KENWOOD TR-9000

SERVICE BULLETIN

SUBJECT: TR-9000 CW, SSB TX INSTABILITY

SUBJECT: TR-9000 TX PULSE NOISE IN SSB MODE

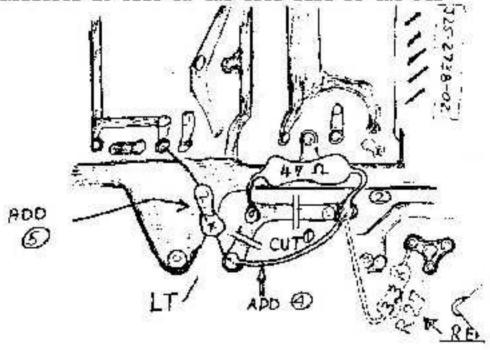
Complaints of FMing in SSB, or CW chirp may be eliminated by minor changes to the TX mixer circuit.

On the TX unit X56-1370-10, perform the following changes:

- 1, Cut the LT foil path.
- 2. Install a 470 resistor on the foil side of the PCB.
- 3. Remove R27, 3.3KN and delete.
- 4. Jumper the cut foil.
- Install a 2.2KR resistor from Q12 collector to the modified LT foil on the foil side of the PCB.

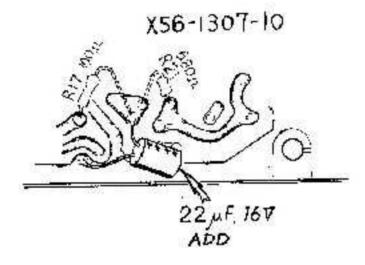
Pulse noise heard during SSB transmission may be reduced or eliminated by adding one capacitor to the TX unit.

On the TX unit $\times 56-1307-10$ add a $22 \mu F$ 16V radial lead cap to the PMB line, as illustrated, on the foil side of the PCB. No ajustments are necessary.

SUBJECT: TR-9000 Temperature Stability Improvment

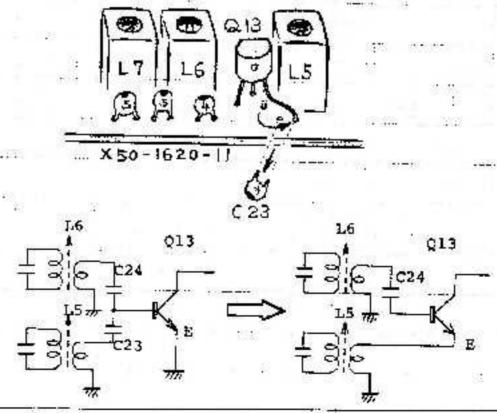
PLL noise or unlock at high temperature may be cured by changing a mixer feed point in the PLL.

Measure TP3 on the PLL unit. If greater than 0.5v RMS signal is available, this change will not be required. If less than this level is present, proceed.

On the PLL unit X50-1620-00 at Q13:

Remove and delete C23.

Connect Q13 emitter to L5 "hot" (original C23 take-off.)

3. Realign 15, 6, 7 for at least 0.5v RMS at TP3.

To align 16 & 7, first position the slugs flush with the tops of the coils, then alternately adjust these two coils for maximum output at the first peak into the coil (fundamental frequency). Then align 15 for maximum.
